ZONING AMENDMENT,
PLANNED UNIT DEVELOPMENT &
SUBDIVISION STAFF REPORT

Date: March 1, 2007

Hillcrest Commons Subdivision, Phase Two

Southeast corner of Chandler Street and Rosedale Avenue
(Prescriptive right-of-way to be vacated)

SITE PLAN

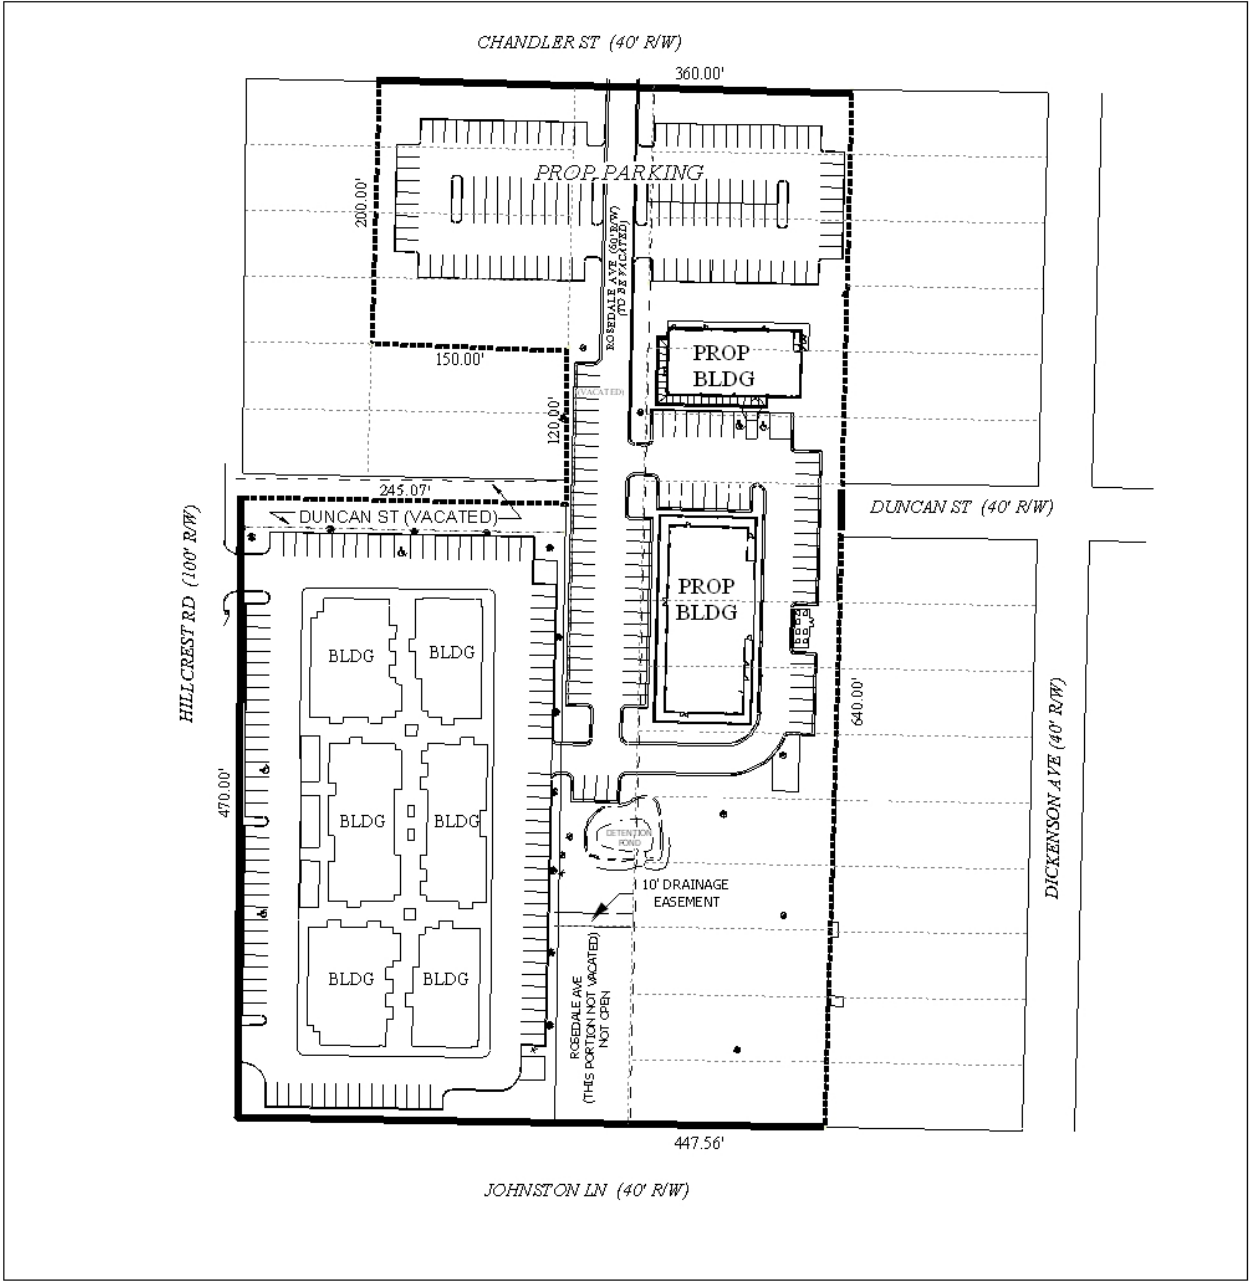
As the property to be rezoned is currently unimproved, there is no “neighborhood character” to be impacted, other than that of the adjacent properties facing Dickenson Avenue; providing buffers could address this impact. The site plan should be revised to show the proposed parking as meeting the buffer setback requirements. The rezoning would require compliance with all landscaping and tree planting requirements, as well as compliance with all other municipal codes and ordinances.

The proposed parking area will contain 118 spaces, which adds to the existing 192 spaces within the PUD. The site contains 7 buildings with a total of 46,767 square feet, thus a minimum of 156 parking spaces are required for office uses (the mix of uses within the development has not been specified): the development will have a total of 310 spaces. It should also be pointed out that section 64-4.3.c. of the Zoning Ordinance states that parking areas containing 10 or more cars

must be illuminated during the hours of operation, but that the lighting cannot shine directly into adjacent residential properties or into traffic: a note reflecting this reference should be placed on the PUD site plan.

The existing PUD currently has access only to Hillcrest Road, however, the proposed expansion includes access to Chandler Street. Chandler Street is primarily a residential street, and it has an existing substandard right-of-way width of 40 feet. It should also be pointed out that Chandler Street's intersection with Hillcrest Road lacks a signal, thus traffic from Hillcrest Commons could pose problems for both the residential neighborhood and traffic operations along Hillcrest Road. As part of the PUD and Subdivision process, sufficient right-of-way should be dedicated to provide 25 feet, as measured from the centerline of Chandler Street.

It should be pointed out that the original PUD approval required two points of access between lots 1 and 2 of the Hillcrest Commons Subdivision, Phase 1. It appears, from the current site plan, that the second access point was never provided, thus the site is not in compliance with the existing PUD approval. If a second access point between the existing lots in Phase 1 were provided, the demand for access to and from Chandler Street might be reduced.

The PUD would require full compliance with all landscaping and tree planting requirements, sidewalks, and with all municipal codes and ordinances, as well as approval of stormwater detention facilities by City Engineering. In particular, Traffic Engineering notes that all areas of two-way traffic should conform to the standard 24 foot driveway widths for two-way traffic. Also, as new pavement will be added, verification should be provided that the existing detention facility will be adequate for the increased runoff, or the site plan should be revised to depicted expanded or additional detention facilities that may be required to fully comply with Engineering comments.

- 1) revision of the legal description on the site plan and application so that it reflects the existing lots created by the recorded plat for Hillcrest Commons Subdivision;

- 2) revision of the site plan to show provision of a protection buffer on the East side of the property adjacent to the proposed parking area, in compliance with Section 64-4.D. of the Zoning Ordinance, to include a 6-foot high privacy fence (except within the street setback area) and a 10-foot wide vegetative buffer;

- 3) revision of the site plan to reflect the requested dedication of right-of-way along Chandler Street, and the provision of a sidewalk along Chandler Street;

- 4) depiction of the required screening of the parking area from adjacent residential uses, even if across the street, in conformance with section 64-6.A.3.i. of the Zoning Ordinance

- 5) placement of a note on the site plan stating that provision of required parking lot lighting will be in conformance with Section 64-6.A.3.c. of the Zoning Ordinance, to ensure that lighting does not shine onto adjacent residential uses or into traffic (recommended use of shielded or full cut-off fixtures, and control of lighting so that they do not operate after the business is closed for the day);

- 6) revision of the site plan to depict an additional point of access between the parking areas on Lots 1 and 2 of the Hillcrest Commons Subdivision, per the original PUD conditions approved in 2005; and

- 7) labeling of all common areas, dumpster locations, outbuildings, generators, etc.

SUBDIVISION AND ZONING DETAIL

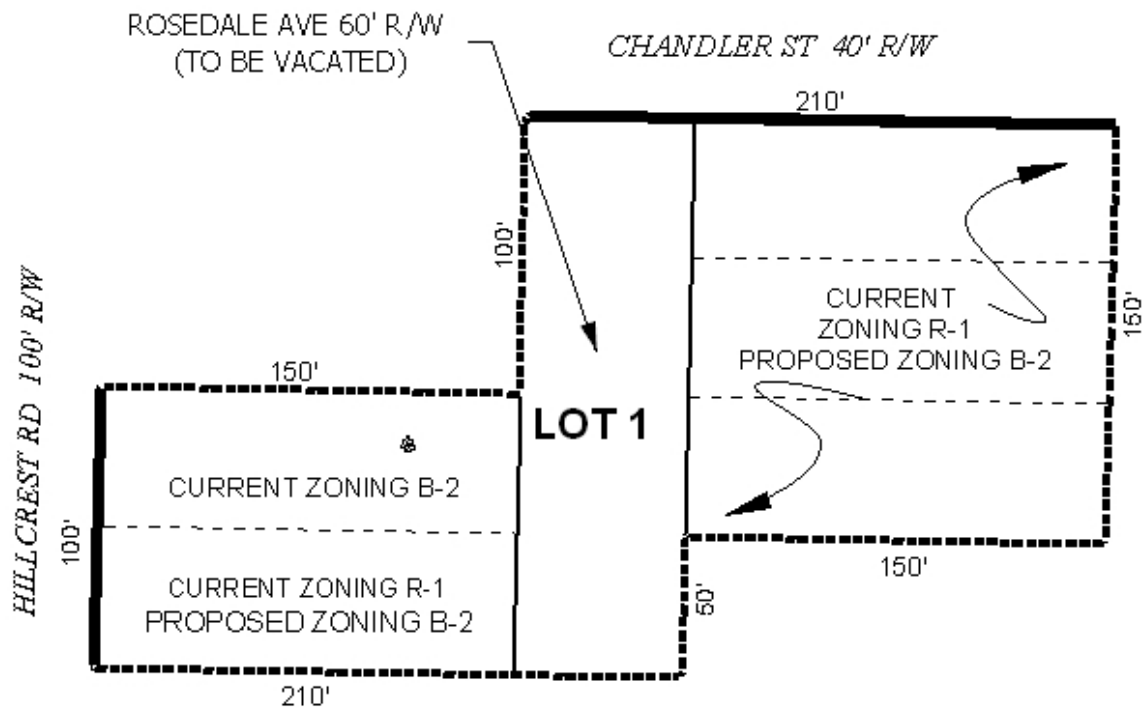
Regarding the proposed subdivision, the applicant proposes to create a 1-lot subdivision from 5 existing lots and vacated right-of-way. Two other existing lots North of the proposed lot, that will become part of the PUD, are not included as part of the Subdivision application. As the proposed parking area will span across these lots, it is recommended that the Subdivision application be revised to include all lots associated with the new parking area, and that they be combined into one new lot.

A portion of the plat illustrated as vacated right-of-way has not yet been vacated (approximately 200 feet of Rosedale Avenue, extending South from the Chandler Street right-of-way); no information has been provided regarding the application status for the vacation of the right-of-way. Completion and documentation of this vacation will be required before recording the final plat or issuance of any permits.

The subdivision and rezoning site fronts onto Chandler Street, a minor street with a 40-foot right-of-way, and includes the unopened right-of-way for Rosedale Avenue, which the applicant plans to utilize once it is vacated. As the right-of-way for Chandler Street is less than the required minimum of 50 feet, sufficient right-of-way should be dedicated to provide 25-feet, as measured from the centerline of Chandler Street.

- 1) inclusion of Lots 1 and 2 of Block 80 of the Pinehurst Subdivision within the proposed one-lot subdivision and rezoning application; and
- 2) revision of the plat to reflect the dedication of sufficient right-of-way to provide 25 feet from the centerline of Chandler Street.
